**Re: NV Energy
Reid Gardner Generating Station Facility ID# H-000530
Source Area 8 Groundwater and Soil Characterization Work Plan**

Re: **NV Energy (NVE)**
Reid Gardner Station (RGS)
NDEP Facility ID #H-000530
Nevada Division of Environmental Protection Concurrence with: *Source Area 8
Groundwater and Soil Characterization Work Plan, Administrative Order on Consent
Activities, Draft March 2016*

Document Title SA-8 Groundwater and Soil Characterization Work Plan

**SA-8 SAMPLING LOCATIONS
UNITS 1, 2, 3 CATCH BASIN
AOC Implementation
NV Energy
Reid Gardner Station
Moapa, NV
Figure 2**

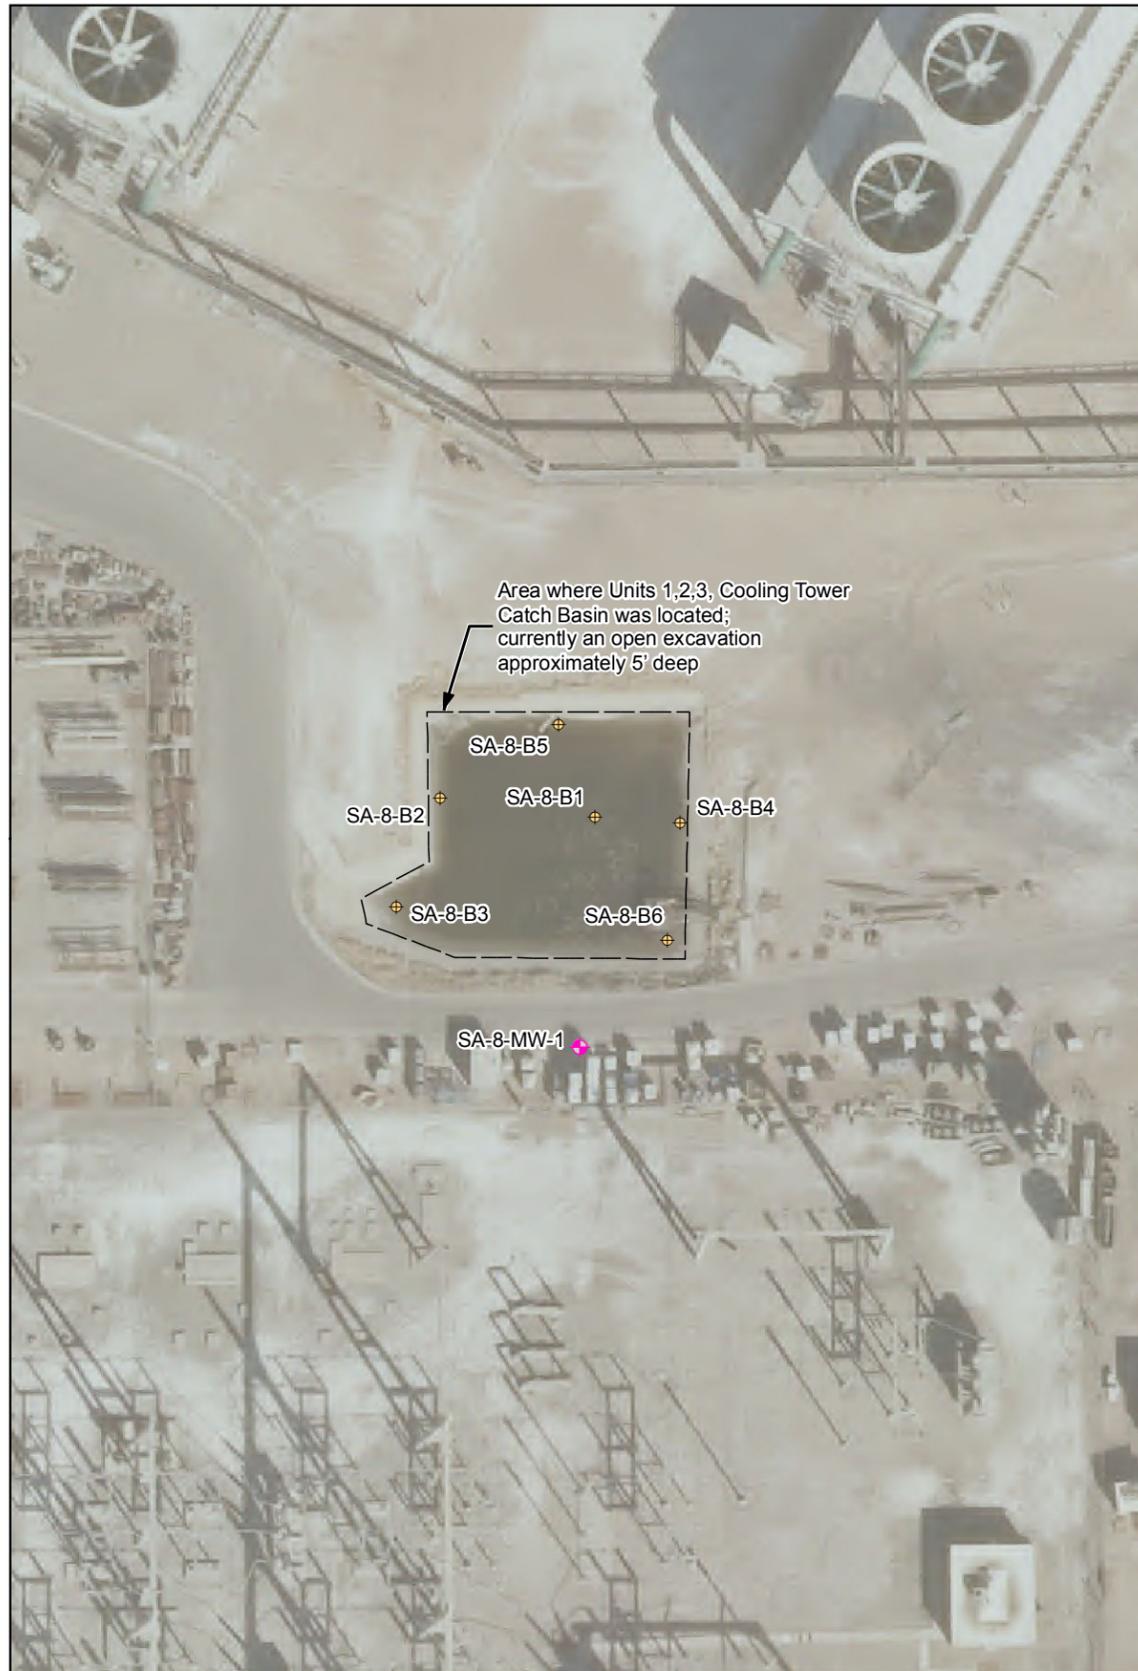
Figure 2: The soil sampling locations do not appear to accurately reflect where surface soil samples were collected, although the proposed well location appears to accurately reflect the current location agreed upon by NVE and NDEP. Please correct the map to accurately reflect the current information for the site.

Figure 2: Please provide additional discussion in the attached table as to the purpose of soil sample B6 (also comment 2b, above). Please amend the table to better describe the reasoning associated with this sample.

Figure 2 showing the sample locations was not revised because the actual sample locations are shown on Figure 2.

The table in figure 2 has been amended to read “The additional sample location (B-6) may be needed in order to conduct a statistical evaluation should there be impacts from the first mobilization. At least 12 total soil samples are needed to conduct a statistical evaluation using the EPA software ProUCL to determine the 95% Upper Confidence Limit (UCL). If the calculated 95% UCL is at or below the BCLs and BTVs, then the area needs no further investigation or cleanup.”
